ADDENDUM #1

VICTORIAN SQUARE INFRASTRUCTURE IMPROVEMENTS PROJECT-SECTION 5

BID # 24/25-010 / PWP # WA-2025-137

SCALE: -
 HORIZ. -
 VERT. -
 JOB NO. -
 SHEET
C5.4
 OF
10

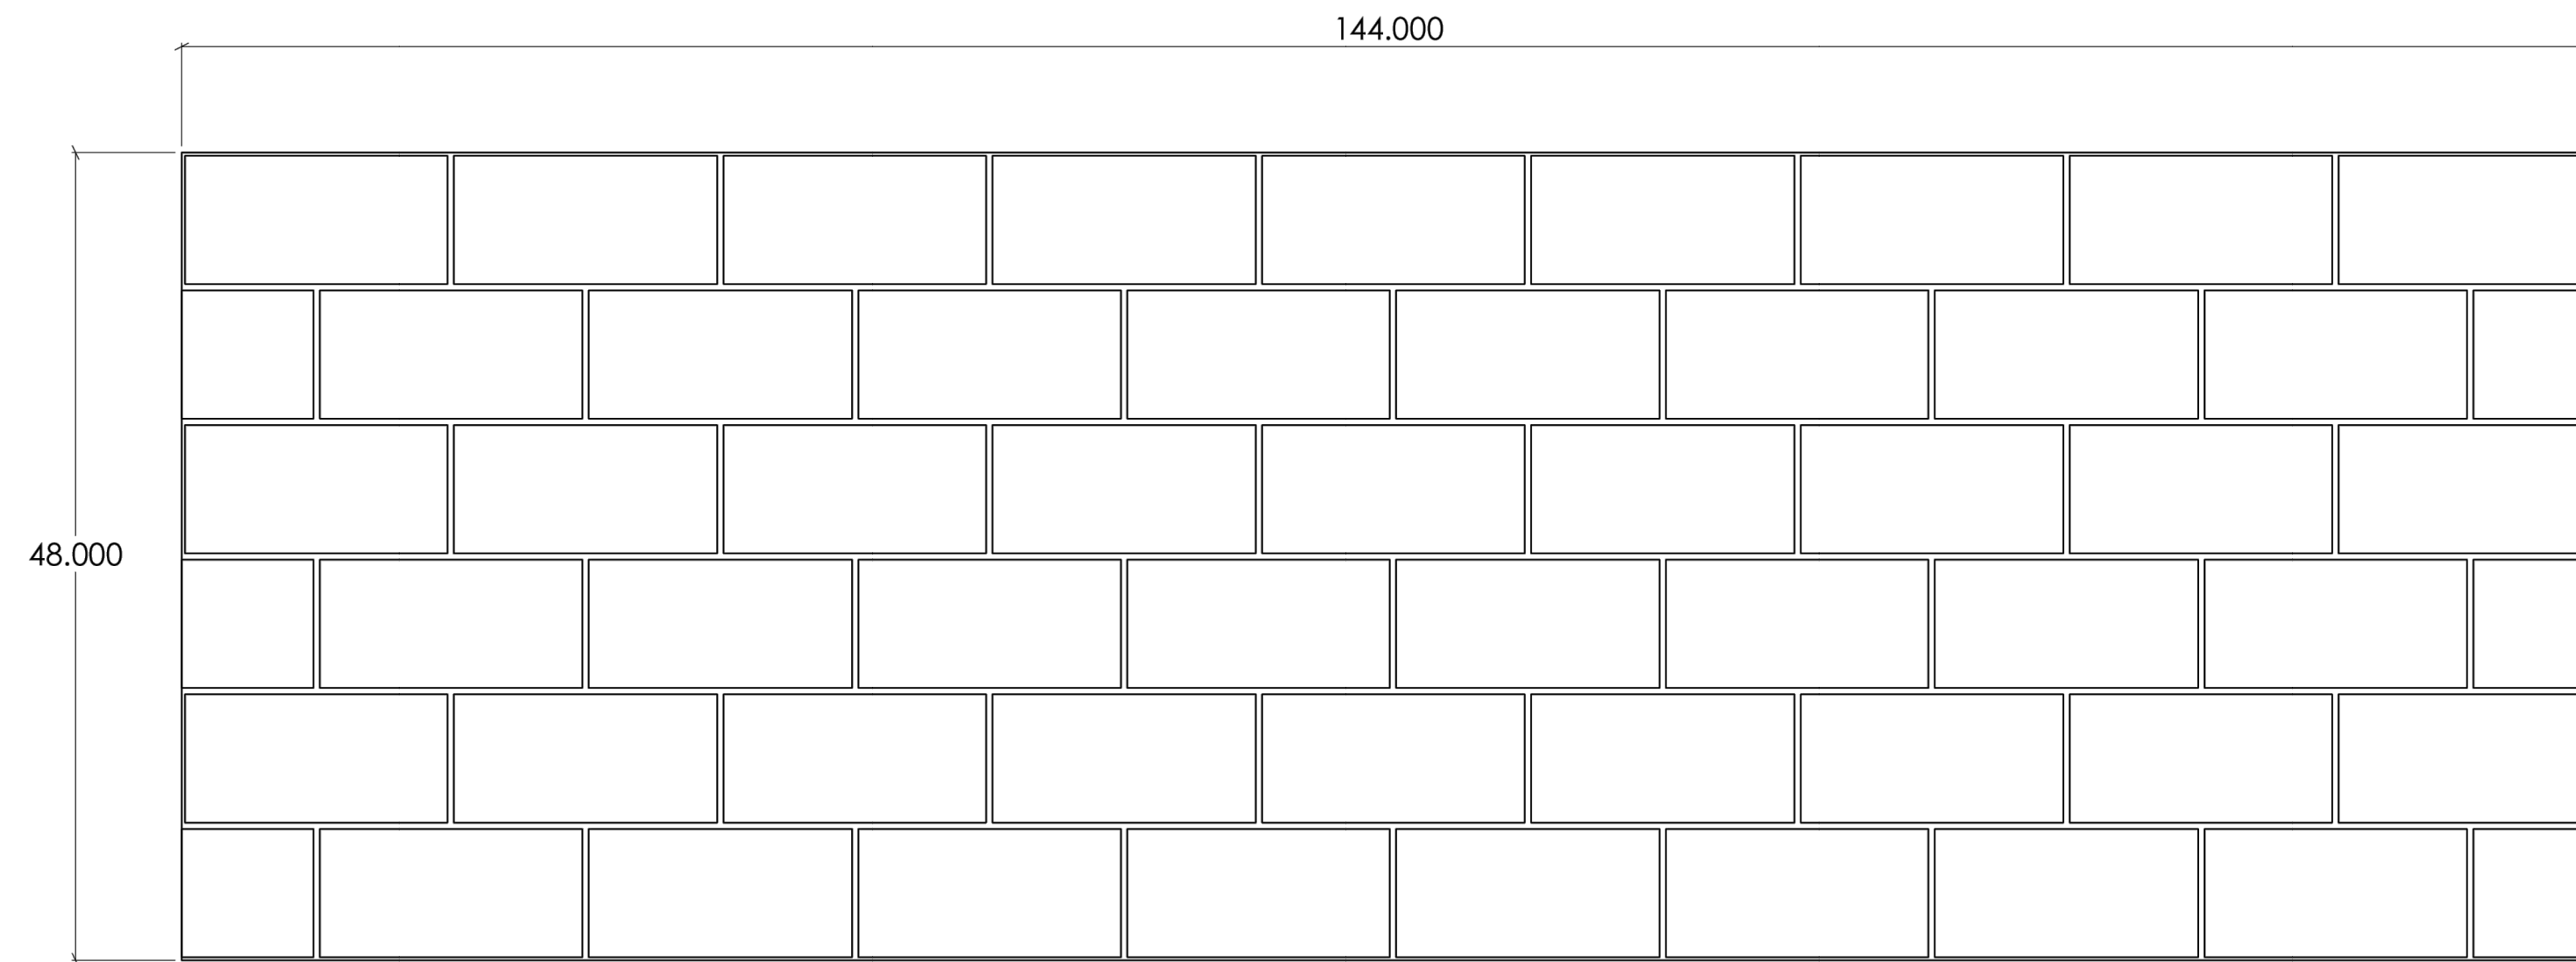
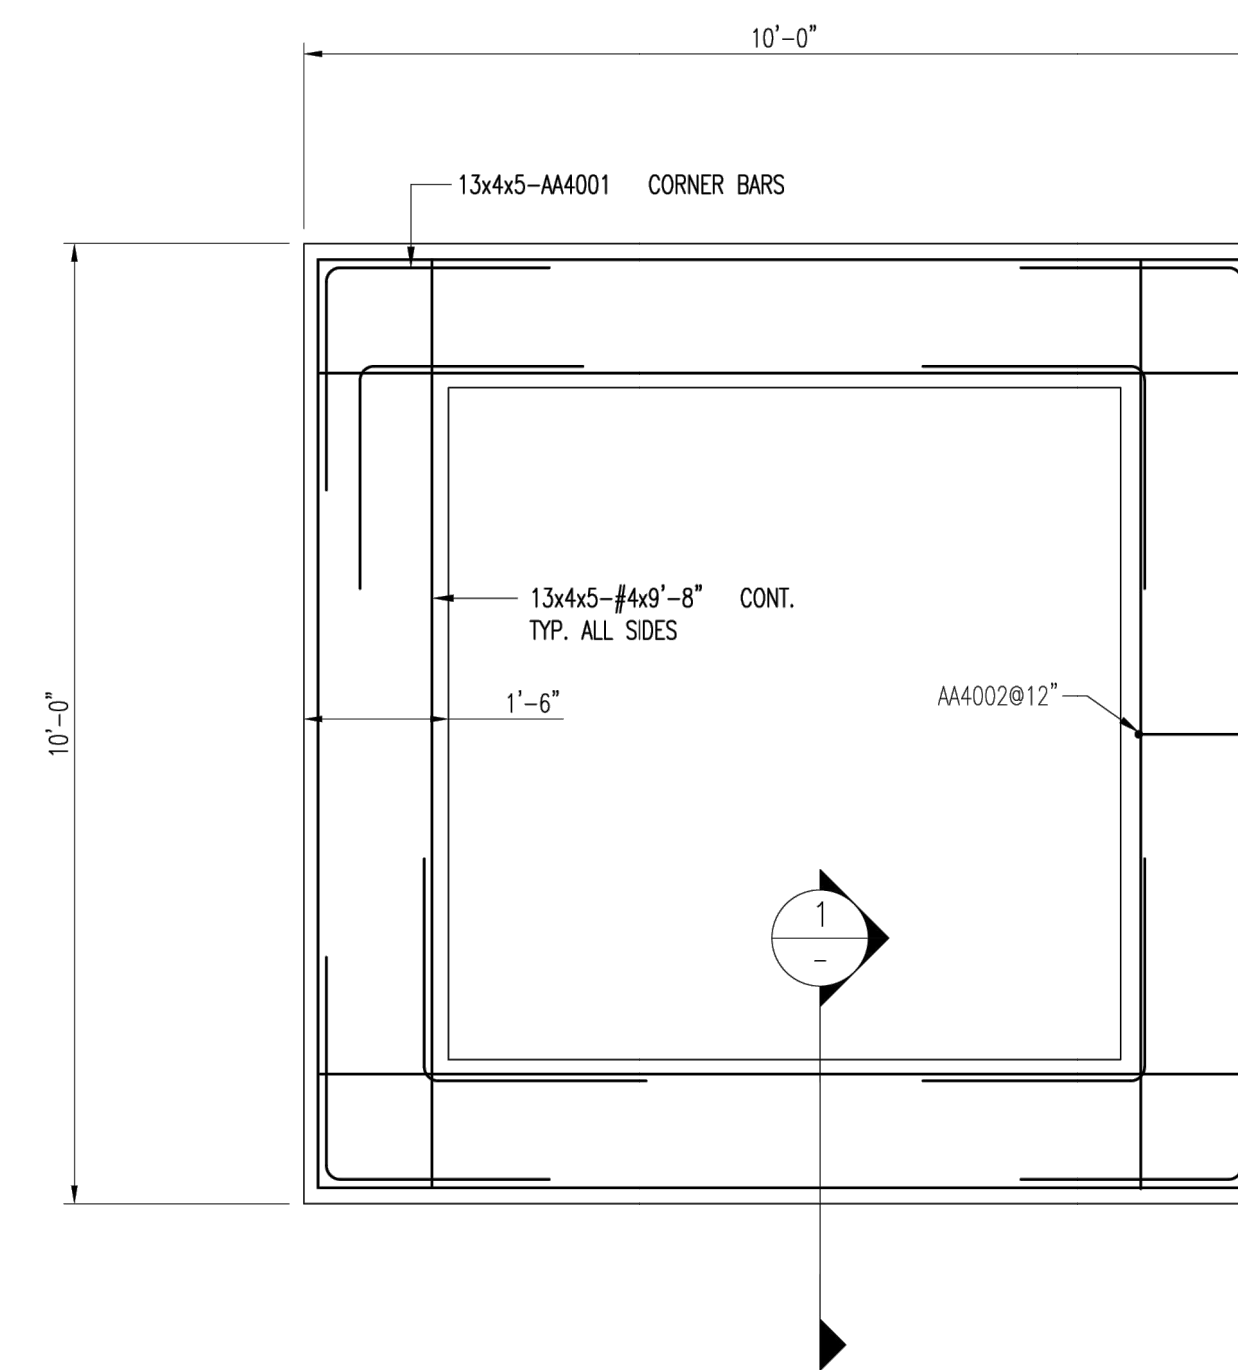
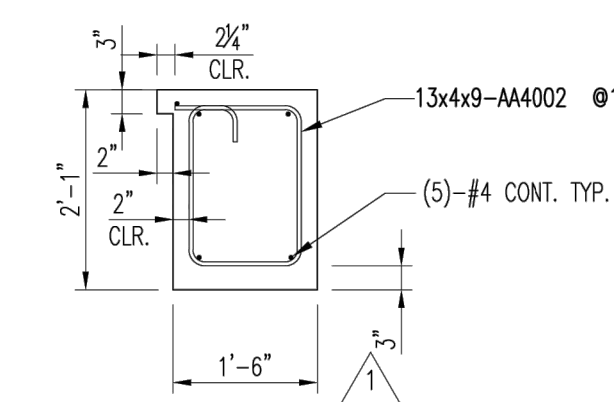
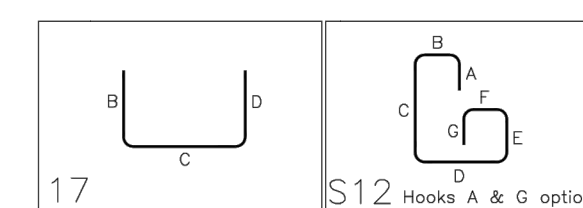
- 3) **Planter details, none found?** Added to plans, sheet C5.4. 14’ x 14’ planter detail are the same as the 10’ x 10’ planter detail only with a larger dimension.

- a. Added sheet C5.4 – Civil Details to include form liner, planter box detail, stain, and patch detail. Included removable bollard installation on the east median at East Victorian Plaza Circle and Victorian Avenue.
- b. Added kiosk colors to site plan sheet C2.0 – Tiffany Tan and Transformer Green.
- c. Added note on sheet C2.0 referencing an additional removable bollard location that is detailed on the upper right corner of sheet C5.4.
- d. Changed “yellow” truncated domes to “red” truncated domes on sheet C5.0.
- e. Added a reference to new sheet C5.4 in the civil sheet index on sheet C0.0.
